UNITED STATES DEPARTMENT OF COMMERCE United States Patent and Trademark Office Address: COMMISSIONER FOR PATENTS P.O. Box 1450 Alexandria, Virginia 22313-1450 www.uspto.gov

| APPLICATION NO.   | FILING DATE                | FIRST NAMED INVENTOR | ATTORNEY DOCKET NO. | CONFIRMATION NO. |  |
|---|----------------------------|----------------------|---------------------|------------------|--|
| 10/585,450  | 07/07/2006                 | Shoji Akatsuka       | Q89687              | 2865             |  |

### **DETAILED ACTION**

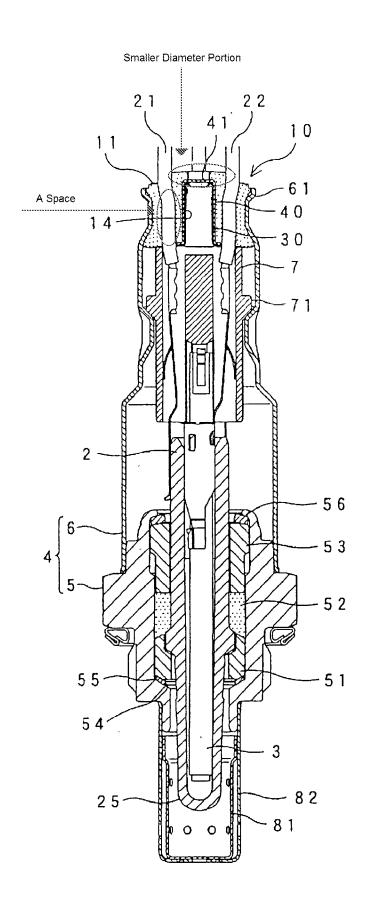
4. Applicant's arguments filed 11/05/2008 have been fully considered but they are not persuasive. Regarding Claims 1, 3, 4 and 8, 9, Applicant argues that the elastic seal member is disposed such that a smaller diameter portion protrudes and such that

the elastic seal member is disposed astride the rear end of the outer tubular member, while at the same time a space is formed between the smaller diameter portion of the elastic seal member and the rear end of the tubular metallic member. Fujita depicts an arrangement that can be so described, shown below.

- 7. Applicant argues that protruding portion 13 of Fujita is the whole of the smaller diameter portion and that Fujita's 13 is not disposed partly inside the tubular metallic member. The examiner believes that the smaller inner diameter portion of Fujita is composed of the elastic seal between wires 21 and 22, which is disposed both inside and outside the tubular metallic member. Furthermore, in claims 6 and 7 Applicant merely claims that "a portion of the elastic seal member protrudes outward from a rear end of the tubular metallic member." Fujita's elastic seal member is clearly disposed partly in the rear end of the tubular metallic member such that a portion protrudes.
